SALEM DEPOT
INTERSECTION IMPORVEMENTS PROJECT
12334
10/6/2020

ADDENDUM 1

PLAN REVISIONS:

Included Sheets: 5-10, 11, 12, 19, 20 30-34, 39, 40, 44-51, 53, 68, 69

Item 609.011 Straight Granite Curb

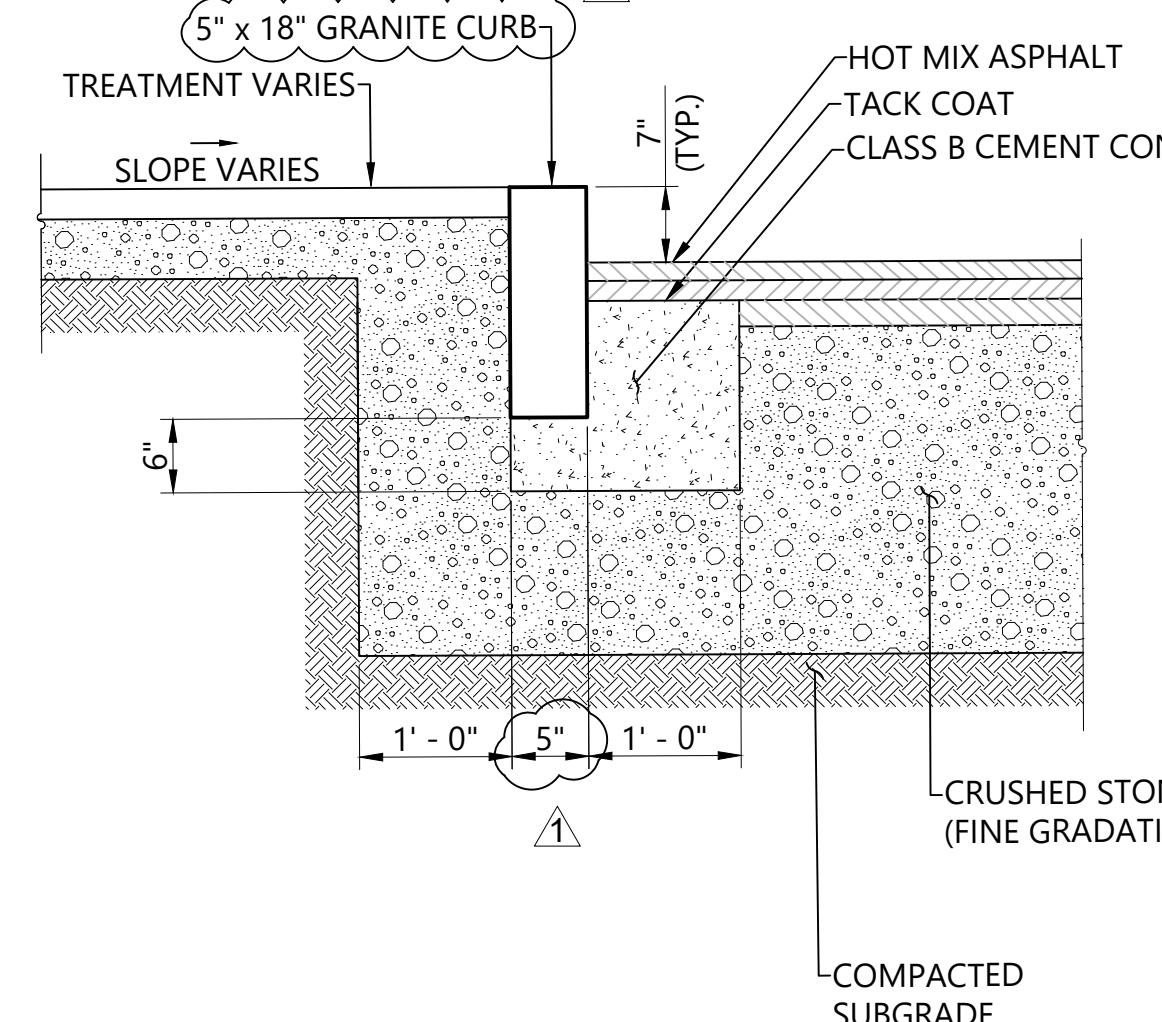
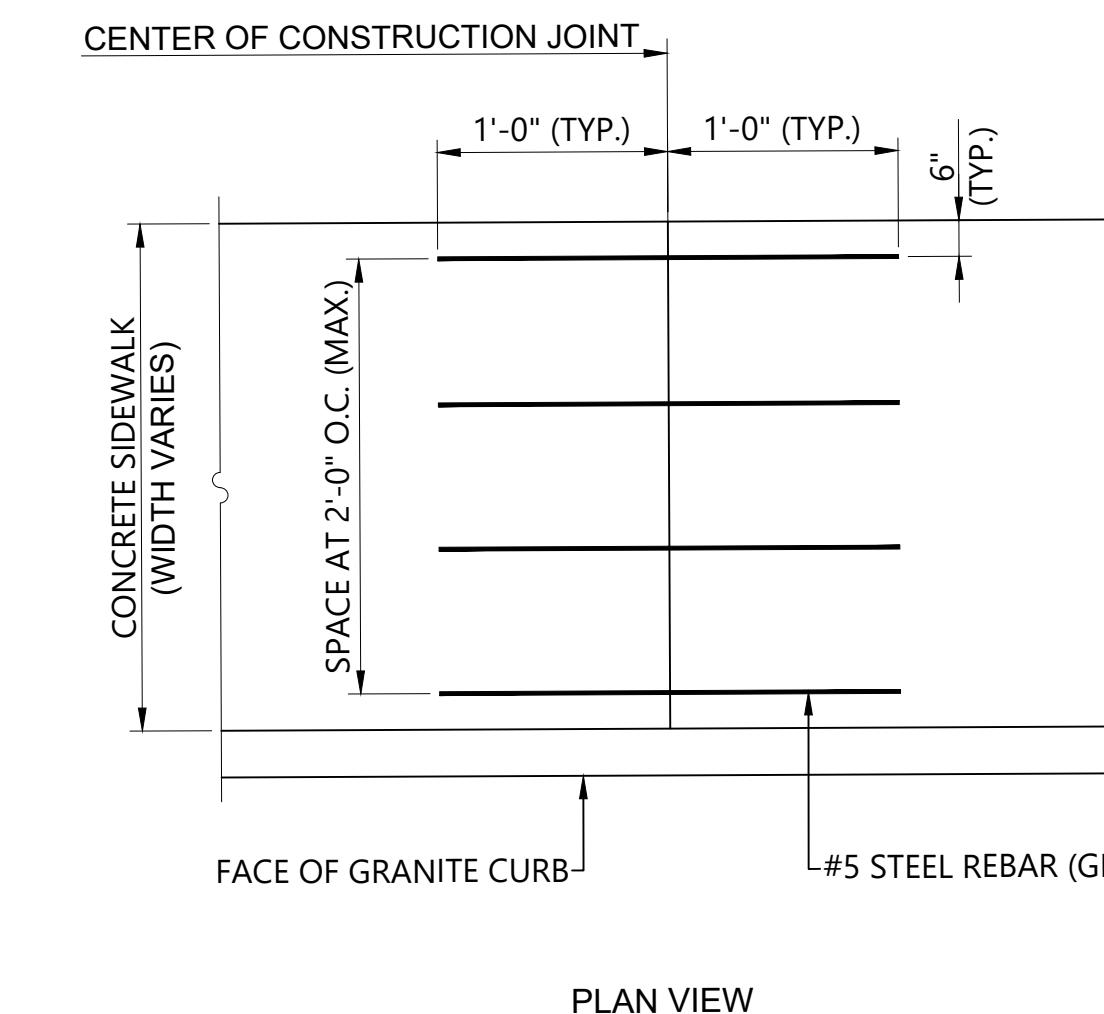
Question: Granite curb detail shows 6", NHDOT standard is 5". Please clarify

Response: The details on plan sheet 11 are incorrect and standard 5" NHDOT curb width shall be used. Note that the details in the plans are otherwise based on Town of Salem construction details, which shall govern.
